**Consumers
Power
Company**

February 20, 1975

Re: Docket 50-255
License DPR-20
Palisades Plant

RESPONSES TO USNRC
Request of February 4, 1975
for Additional Information

B STEAM GENERATOR

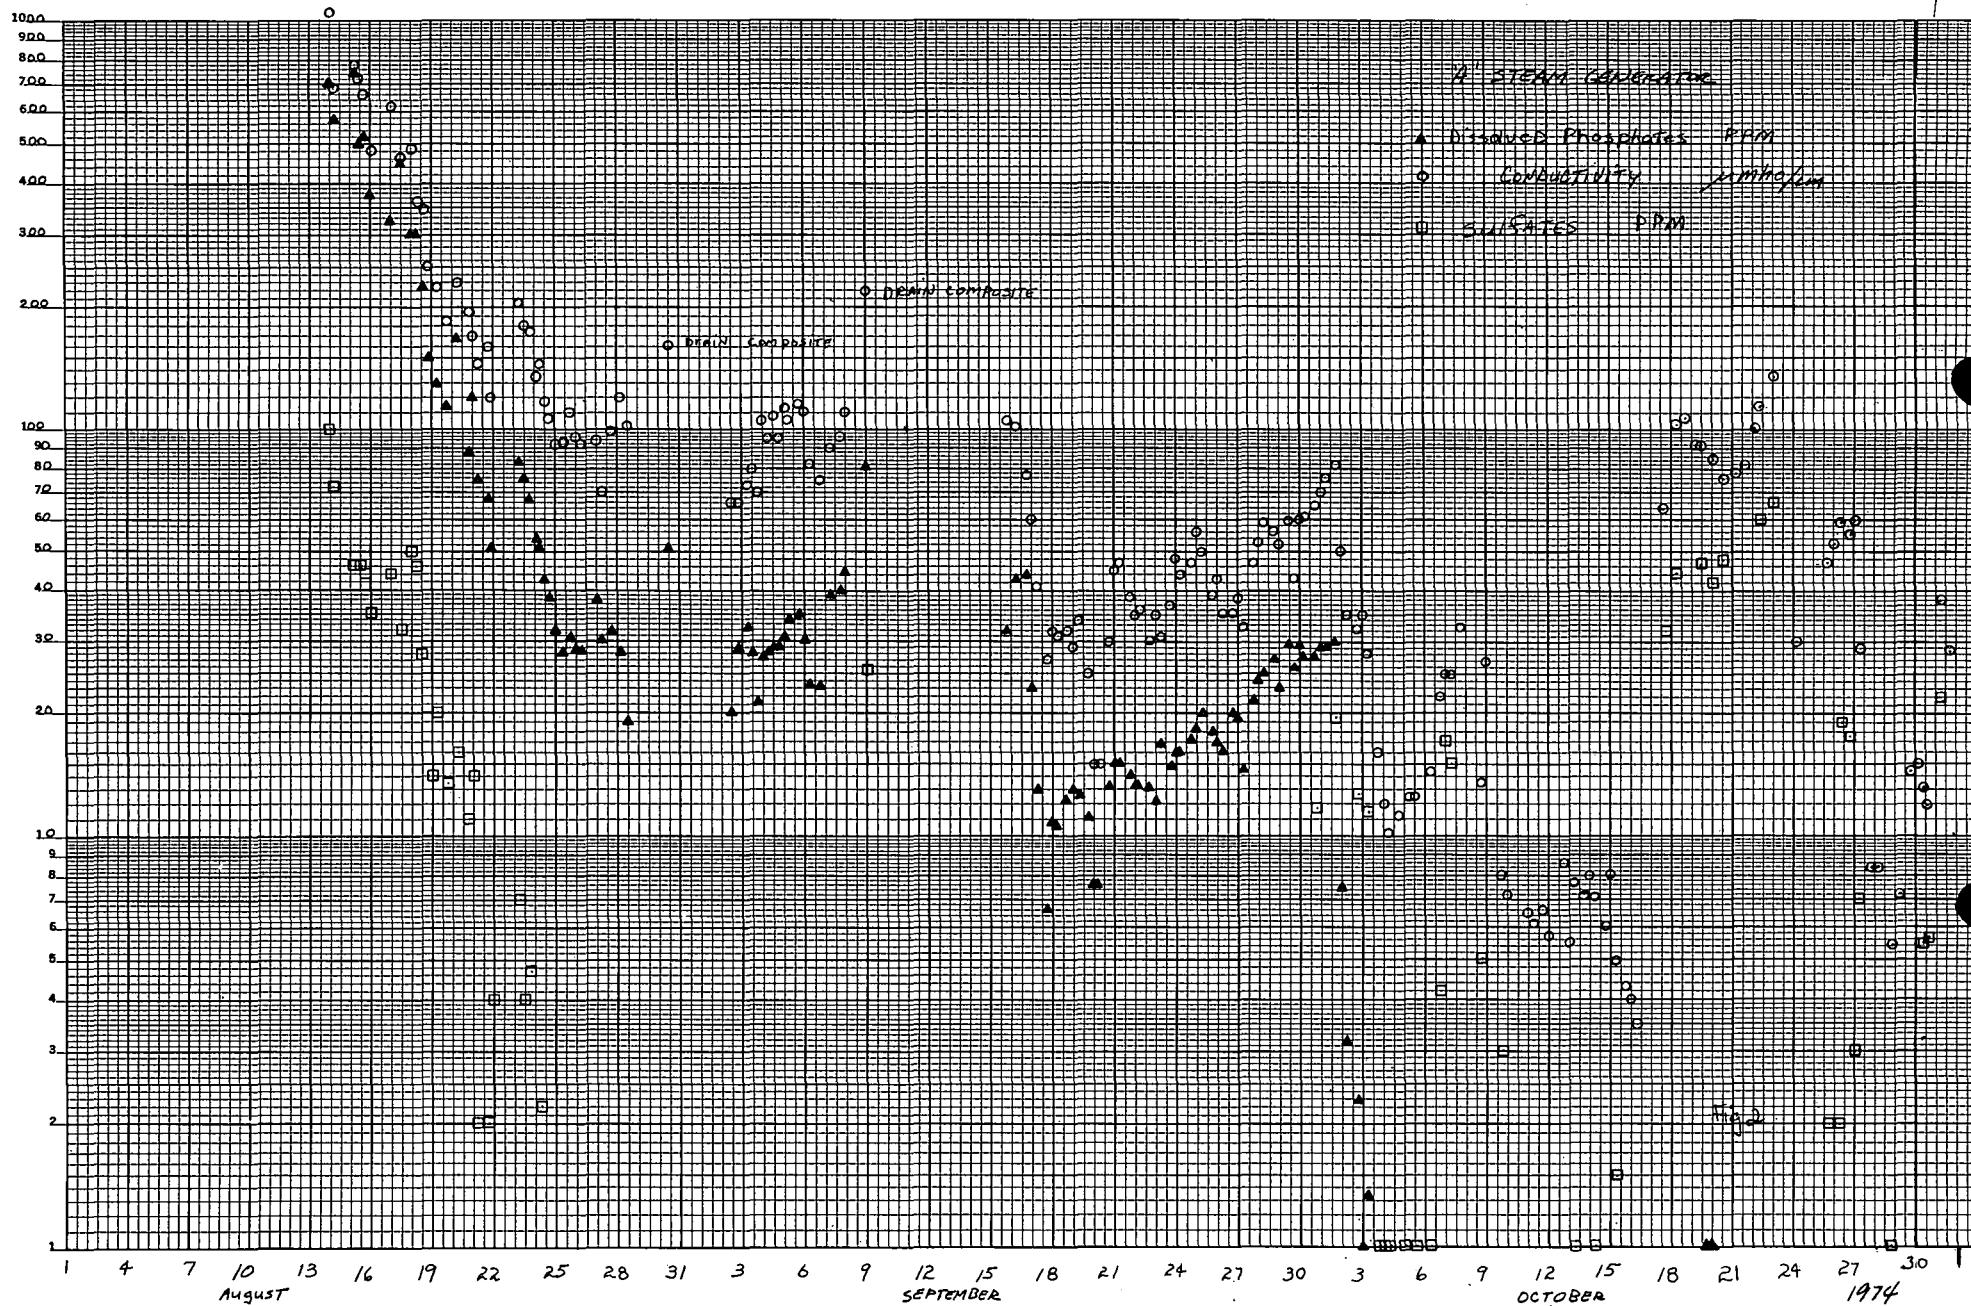
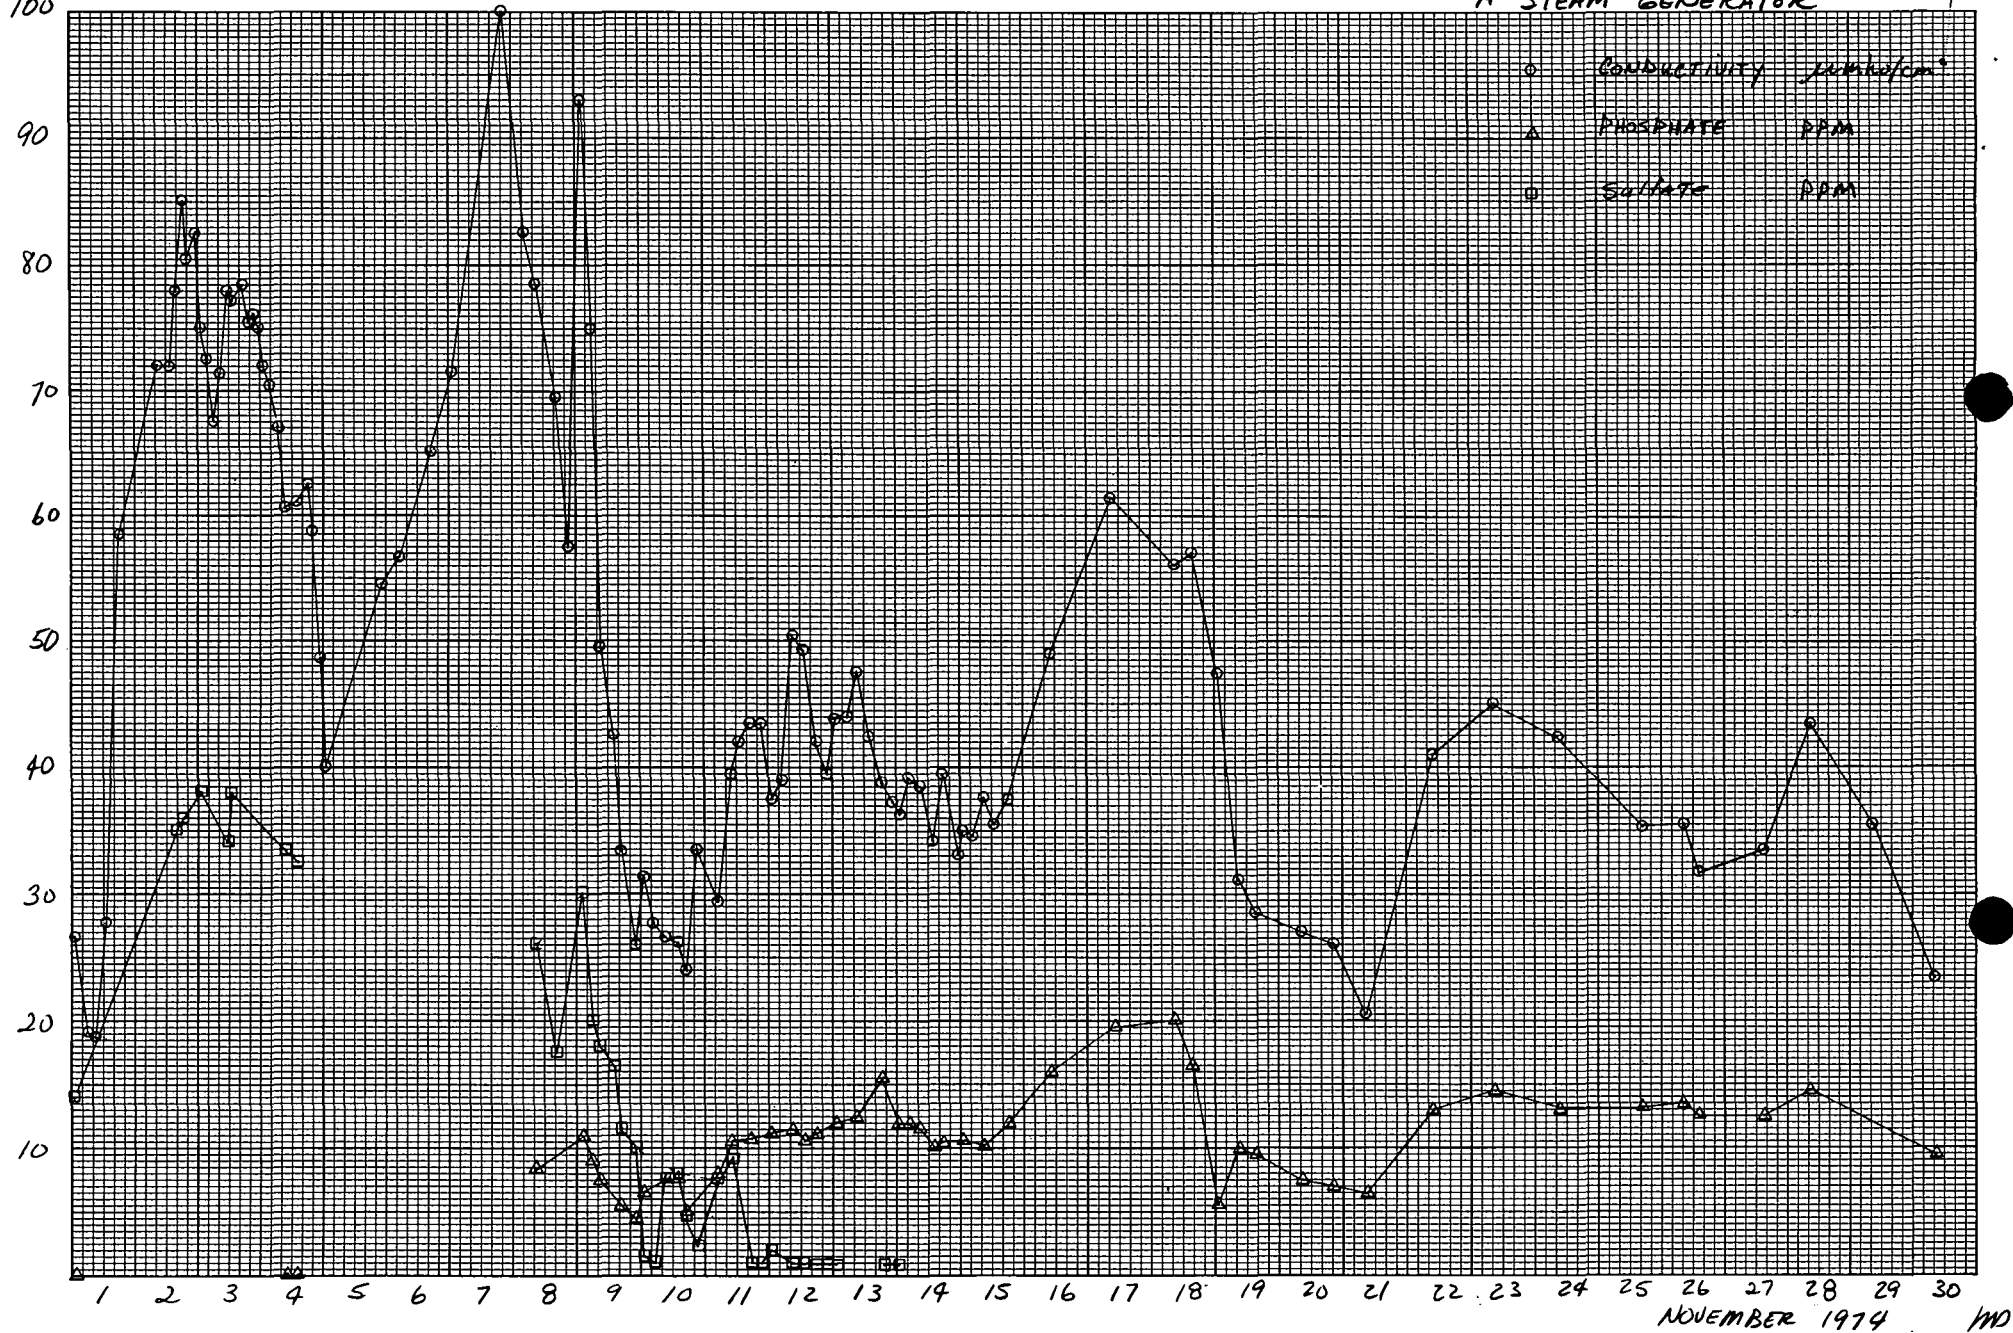
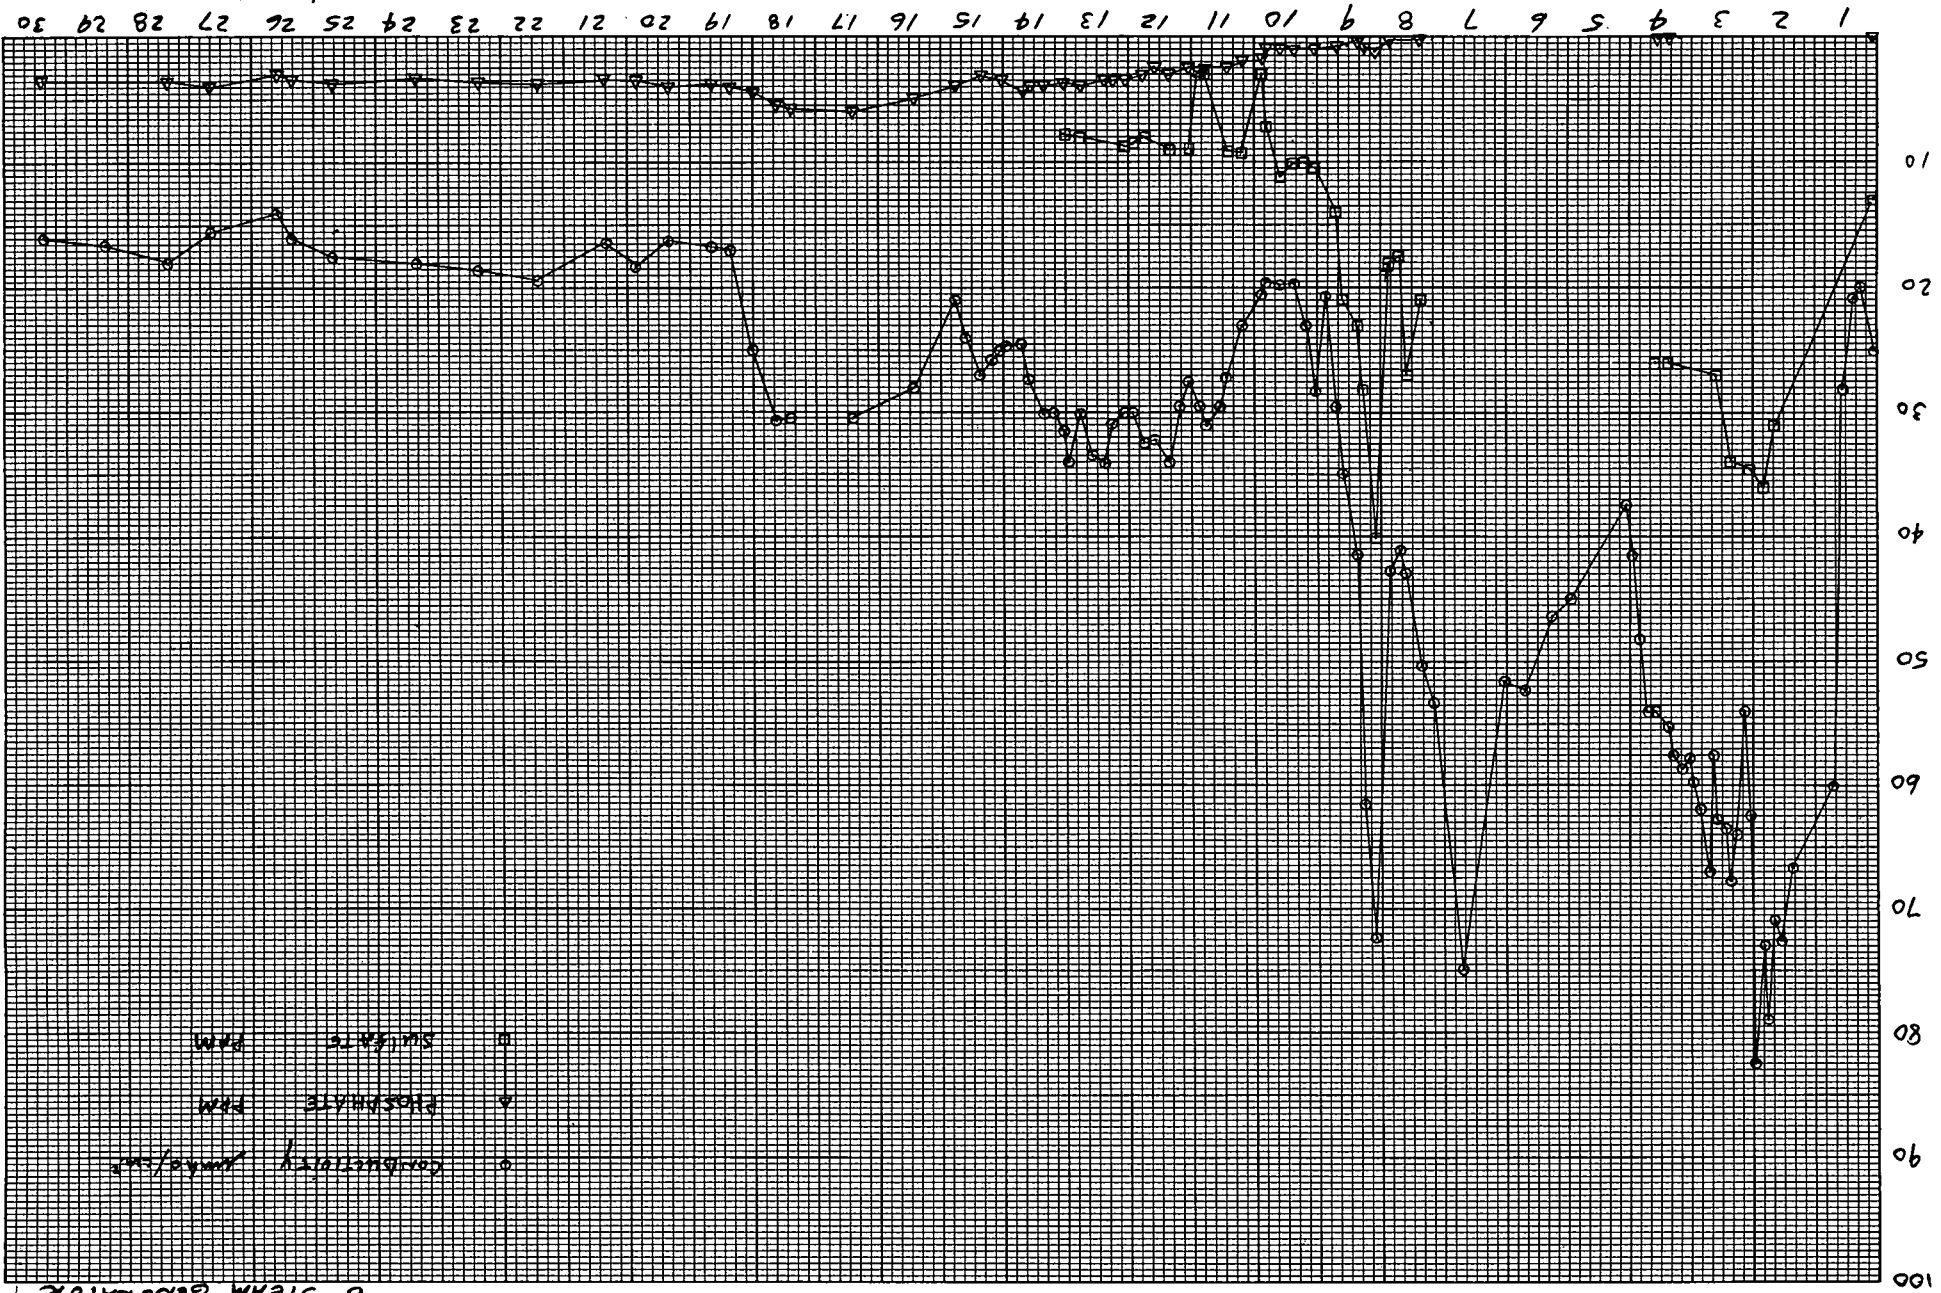
Question 6

"Provide a graph or plot showing the following as a function of time for both steam generators from the onset of isothermal flushing operations to the present:

- a. Phosphate and sulfate concentration,
- b. pH and,
- c. pounds of phosphate and sulfate removed.

The attached graphs, supplemented by the notes listed below, are provided in response to this request.

Notes

1. The letter "D" on several of the graphs indicates a sample (generally a composite) taken during a generator drain.

2. The first accounting of total PO_4 and SO_4 removed from the generators took place in early September; however, due to the error noted late in September with the PO_4 analysis, the total PO_4 removed starts in October. Quite a lot of work would be required to go back and add up the results for the missing four data points (September) and, therefore, it was not done.

3. Due to circulating water leakage (high in SO_4) after October 1, 1974, the pounds of sulfate removed from the generators were no longer calculated. It would be impossible to determine whether we are removing sulfate from the "old sludge" or from the "new sludge" caused by condenser leakage.
